Access Compliance Report

Public Rights-of-Way

Intersection ID: 50633	Main Street: BLUE_BLOSSOM_RD	Cross Street: CORAL_ROSE_RD	Location: E
ADA ID: 6C9D979751EB	Ramp Type: Perp	Initial Pass/Fail: Fail	Overall Compliance: No
Severity Score: 12.5			
Codes/Mitigation Info/Possible Solution		Field Measurements/Component Compliance

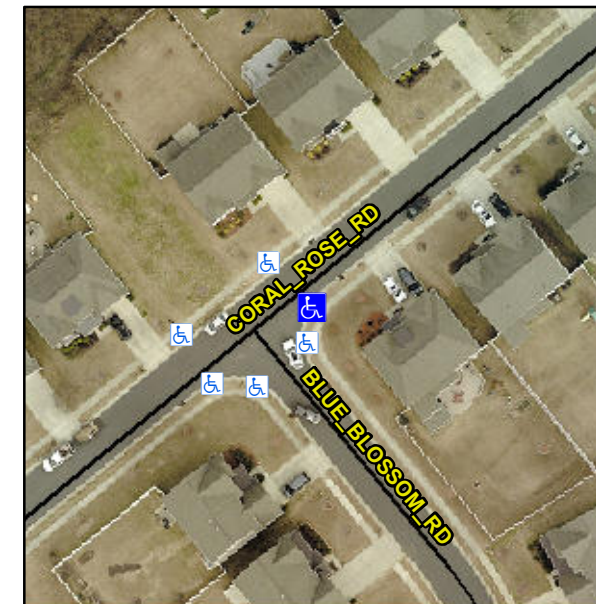
Not Found, R304.2.2

Compliance	Description	Data	Compliance	Description	Data
N/A	Ramp Length (in)	44.0	No	Ramp Slope (%)	8.5
Yes	Ramp Width (in)	48.0	Yes	Ramp XSlope (%)	1.3
N/A	Flare Type LT	N/A	N/A	Flare Type RT	N/A
N/A	Flare Slope LT (%)	N/A	N/A	Flare Slope RT (%)	N/A
N/A	Flare Traversable LT?	N/A	N/A	Flare Traversable RT?	N/A
N/A	Landing Length (in)	N/A	N/A	DWS Provided?	N/A
N/A	Landing Width (in)	N/A	N/A	DWS Contrast?	N/A
N/A	Landing Slope (%)	N/A	N/A	DWS Length (in)	N/A
N/A	Landing X Slope (%)	N/A	N/A	DWS Full Width?	N/A
N/A	Landing Curb? (Y/N)	N/A	N/A	DWS Offset (in)	N/A
N/A	Shared Landing?	N/A			
N/A	Gutter Ponding?	N/A	N/A	Gutter Slope (%)	N/A
N/A	Gutter Lip Ht (in)	N/A	N/A	Gutter X Slope (%)	N/A
N/A	Painted X Walk1?	No	N/A	Painted X Walk2?	N/A
	X Walk 1 Direction	To NW		X Walk 2 Direction	N/A
N/A	X Walk 1 Width (in)	N/A	N/A	X Walk 2 Width (in)	N/A
	X Walk 1 Slope (%)	2.6		X Walk 2 Slope (%)	N/A
	X Walk 1 X Slope (%)	0.7		X Walk 2 X Slope (%)	N/A

Remove & Replace Entire Ramp.
